City of Surrey
PLANNING & DEVELOPMENT REPORT

Application No.: 7921-0186-00

Planning Report Date: June 27, 2022

to permit the development of a 7-storey seniors independent living building with 62 dwelling units, a coffee shop, restaurant, and wellness spa at Elim Village.

Excerpt from A02.2 highlighting:

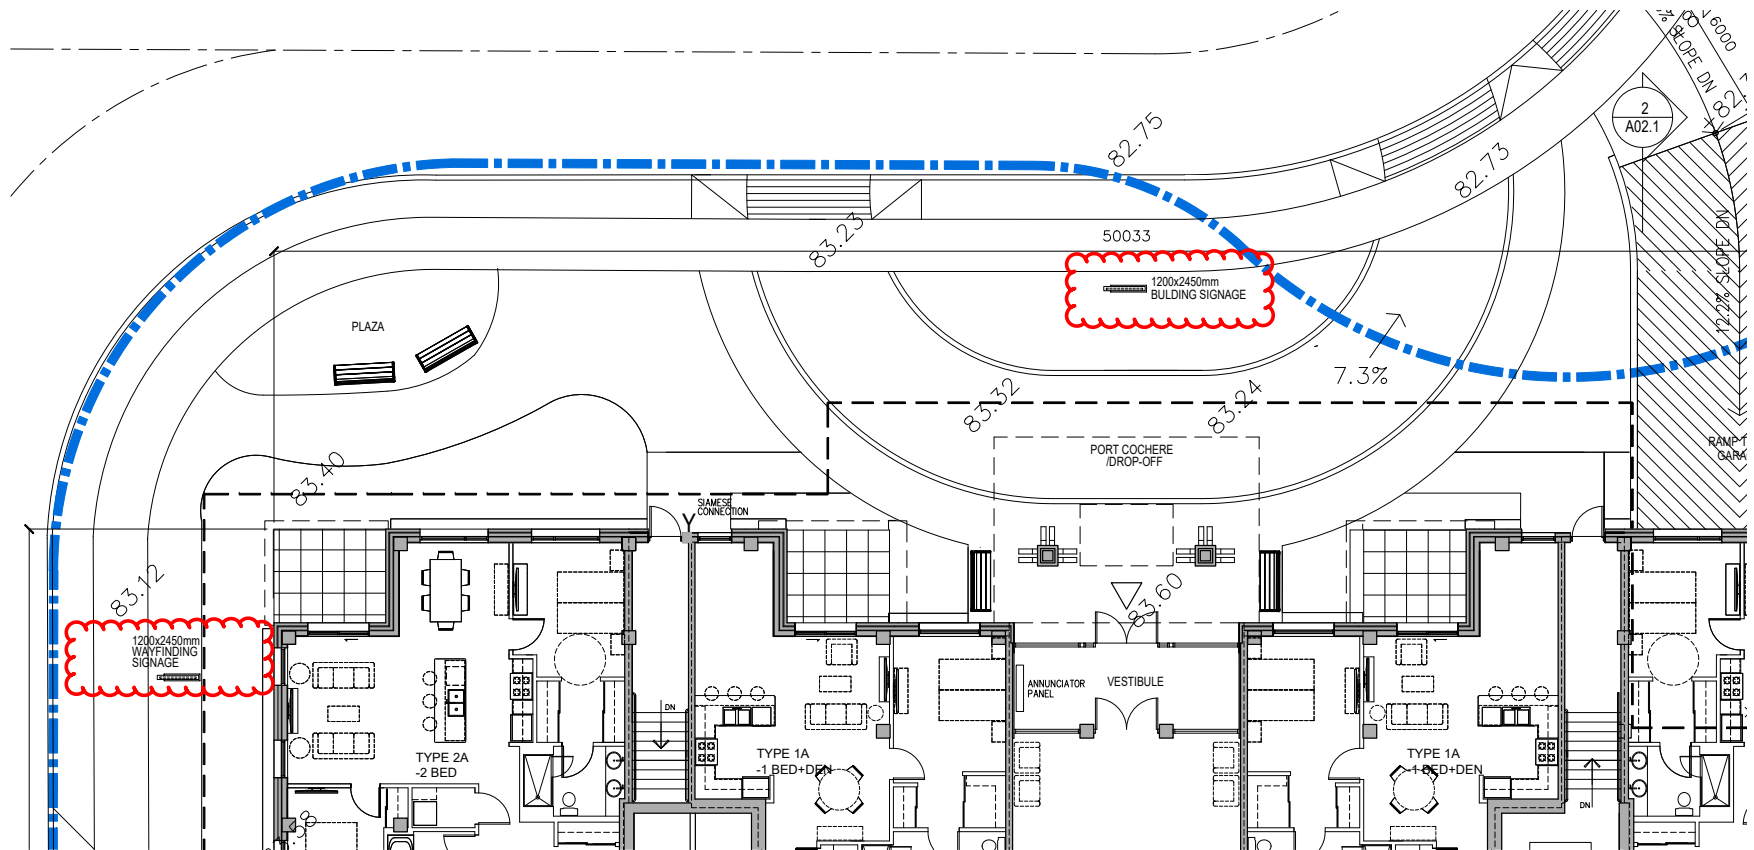
- *Building sign*
- *Way-finding sign*
